# ADA Curb Ramp New Construction Inspection Form (Parallel)

<b>Main</b>	<b>24952.54</b>			<b>Wascoe</b>
North-South Road Name	Project No.	Sheet No.	Intersection No.	East-West Road Name
<b>Calibration Date</b> <span style="border: 1px solid black; padding: 2px;">10/8/2024</span> (mm/dd/yy)

PARALLEL RAMP (PL)

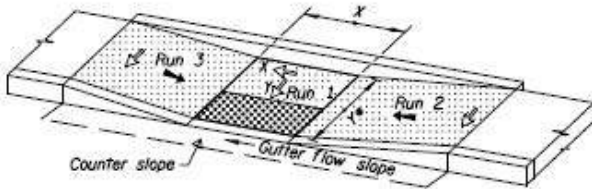
Rr3 gravel. No end of walk barricade.  
IITD gt2. Crack in rr2. No end
